STATE OF MARYLAND APPLICATION FOR PERMIT TO DRILL WELL

HO-94-3871 fill in this form completely

Property Address: 12738 Lime Kiln Rd

LOT 38

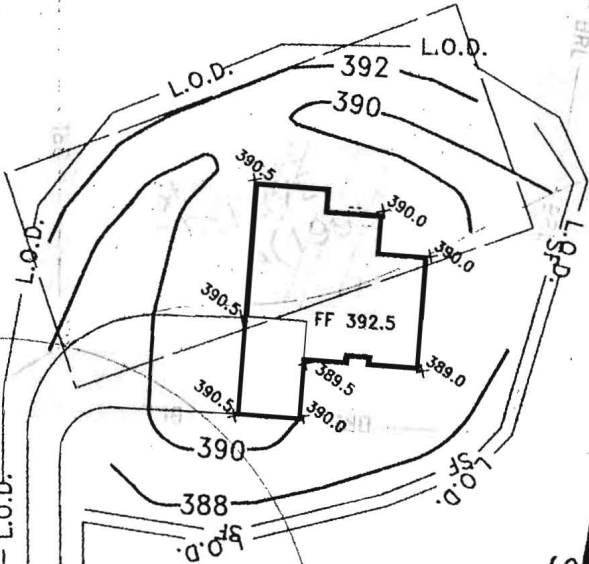
Telephone call to Mr. Neal Howe to discuss well issue. Plan does show the well is not in a direct drainage path of the SDA, however, Mr. Howe has informed me that the well is only 7' from the property line. This does not conform w/ 26.04.04.05. B(2)(i) ~~to~~ ~~allow~~ which states 10' from property line. Told Mr. Howe to either modify plat or re-drill well to obtain 10' sep. setback. STB

Well site OK
staked by surveyor
MR 12/8/04
